City of Ryde

Request for DGRs for North Ryde Station Precinct – Ryde LGA (SSD-5093)

Draft State Significant Site Study Requirements – North Ryde Station Precinct

Comments for Draft DGRs for North Ryde Station Precinct

Figure 2: Congestion Effects, with/without Road 38, AM Peak

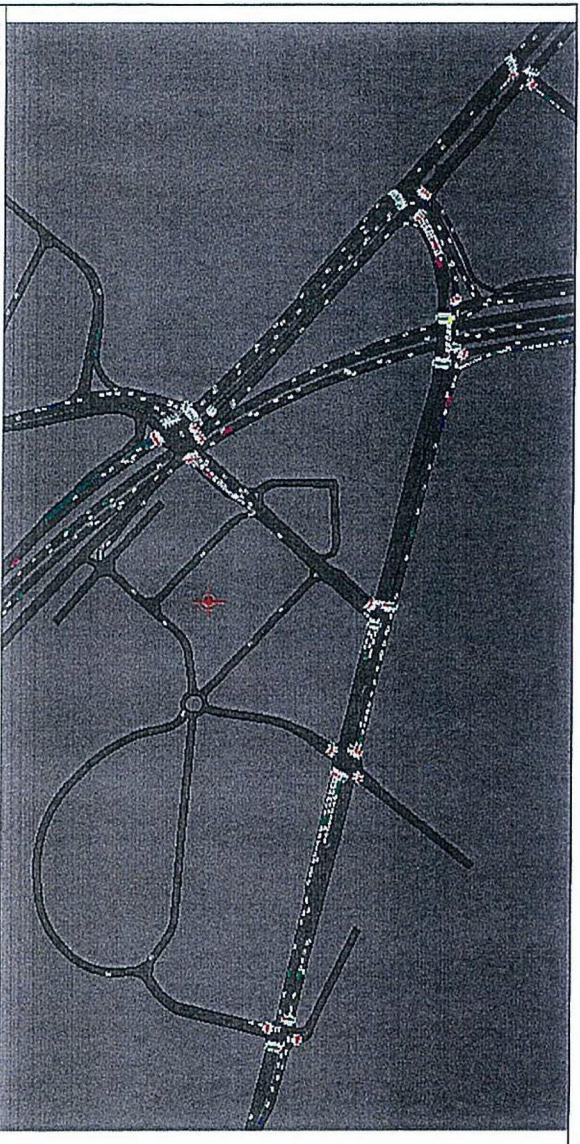
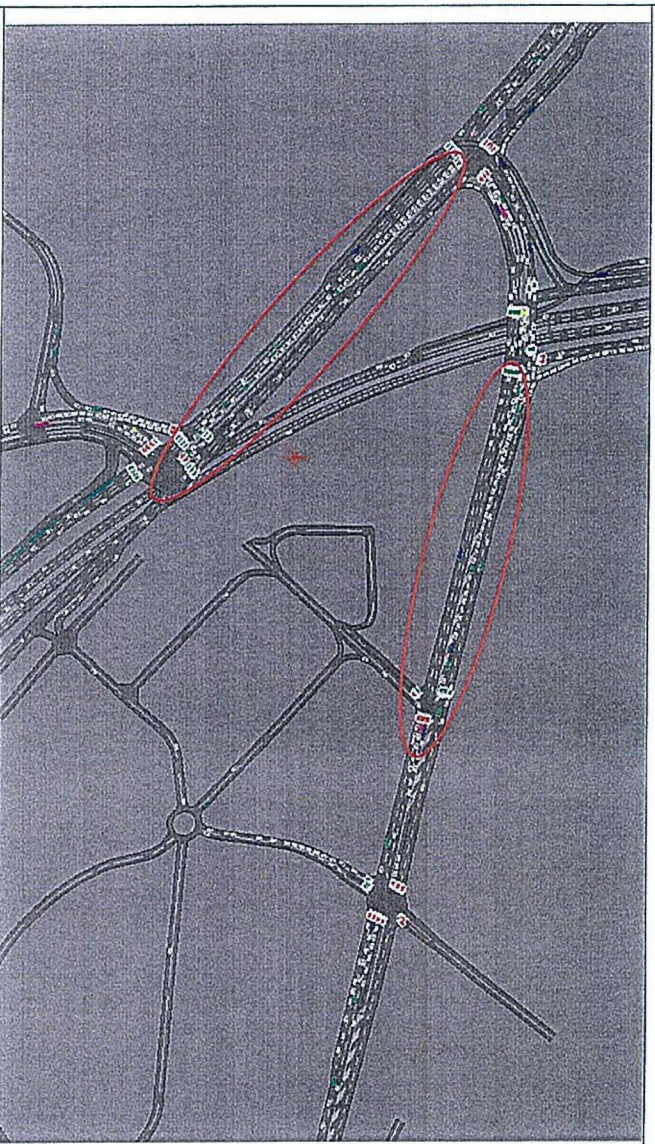
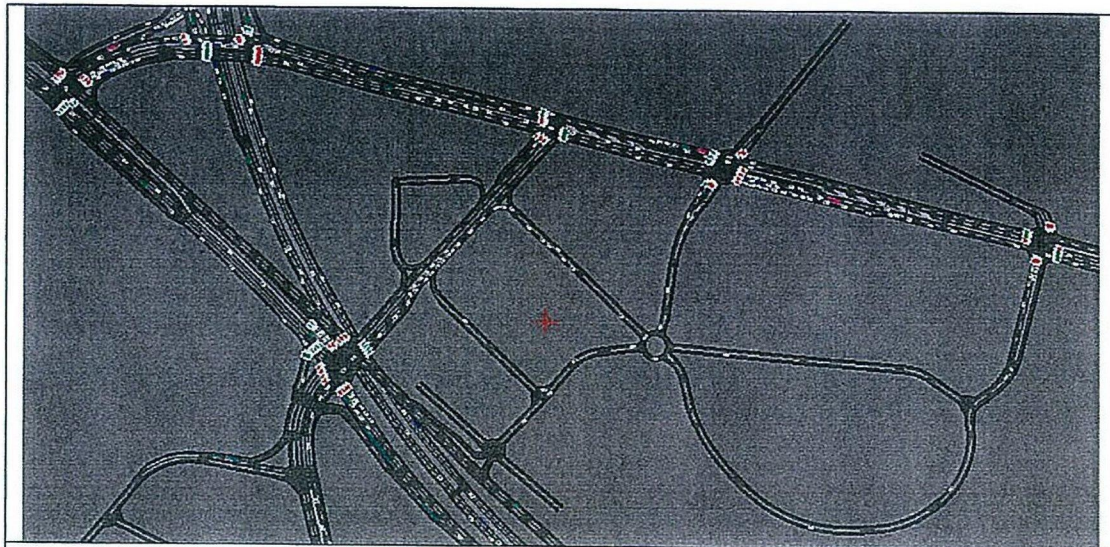
Figure 2 shows the congestion levels in the 2031 morning peak with full development of the precinct for with and without Road 38 in place. The removal of Road 38 results in a much heavier demand for right turns from Epping Road into Delhi Road, filling out the available dual lane pocket space. The traffic destined for Zone 24 also fills out the available pocket length for right turn into the western most signalised access to the TIDC site off Delhi Road. This in turn queues out into Delhi Road, affecting the ability for M2 southbound off ramp traffic to clear and then queuing back to the M2. Whilst additional right turn pockets at the Zone 24 access intersection may improve the situation at this location, it is unlikely that the filling of the right turn pockets from Epping Road into Delhi Road would be as easy to solve, as these are already quite long lanes.

Figure 3: Congestion Effects, with/without Road 38, PM Peak

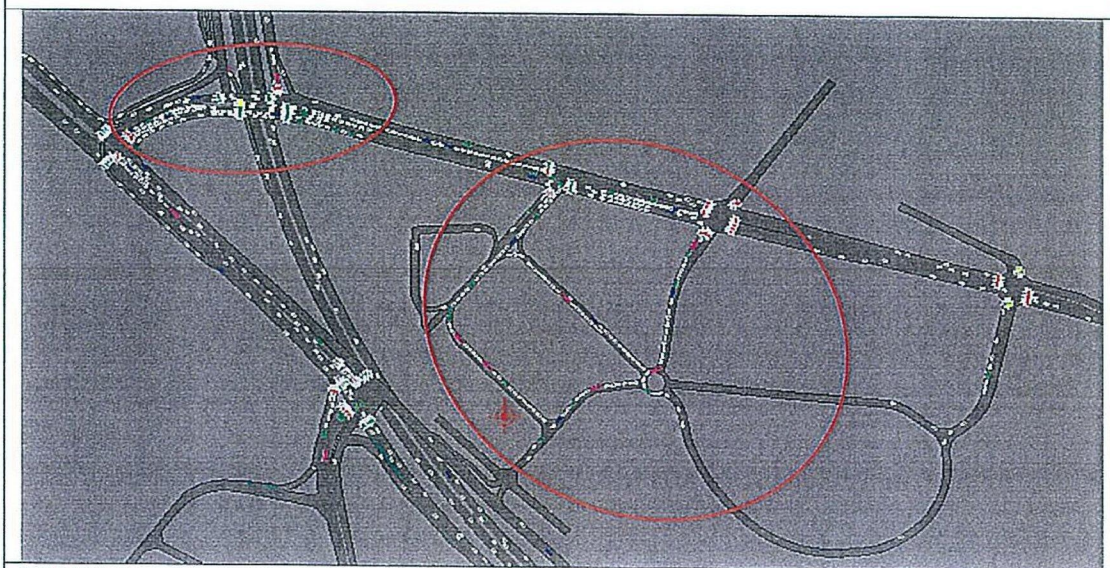
Figure 3 shows traffic queues in the vicinity of Zone 28 with and without Road 38 in the afternoon peak. This figure clearly demonstrates that without Road 38, there is insufficient exit capacity for traffic leaving the precinct. This figure also shows (as expected) that traffic leaving the precinct to travel east (via Epping Road) and south (via Pittwater Road) will increase queue lengths at the Delhi/Epping and Pittwater/Epping intersections.

Figure 4: Route Choice with/without Road 38

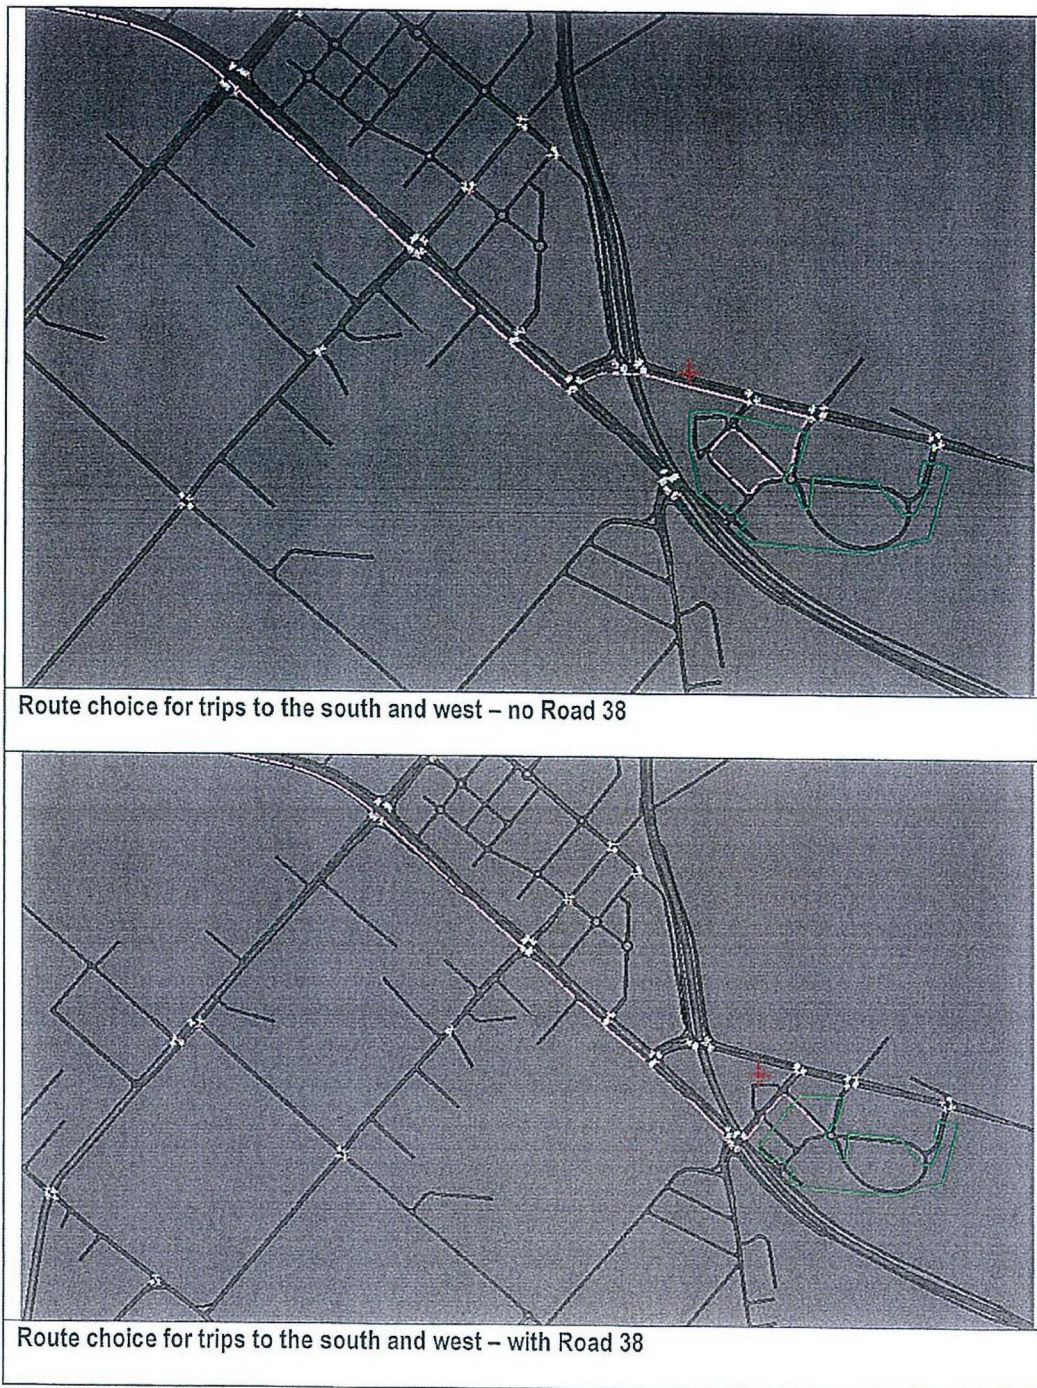
Also, as shown in Figure 4, with no Road 38 all traffic leaving the precinct destined for the south and west needs to pass through the Delhi Road/M2 interchange further congesting this area rather than using the less congested Epping Road.
